Access Compliance Report

Public Rights-of-Way

(Curb Ramps)

Intersection ID: 31893	Main Street: CHAPECLANE_RD	Cross Street: GREEN_MOUNTAIN_RD	Location: NE
ADA ID: 89E38B238C1C	Ramp Type: PerpDiag	Initial Pass/Fail: Fail	Overall Compliance: No
Severity Score: 25			
Codes/Mitigation Info/Possible Solution		Field Measurements/Component Compliance

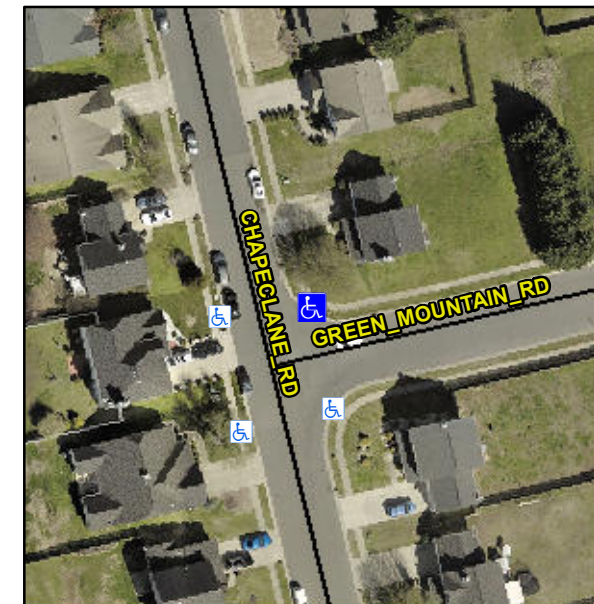
Remove & Replace Curb Ramp With Two New Directional Ramps or Equivalent.

Not Found, R304.5.3
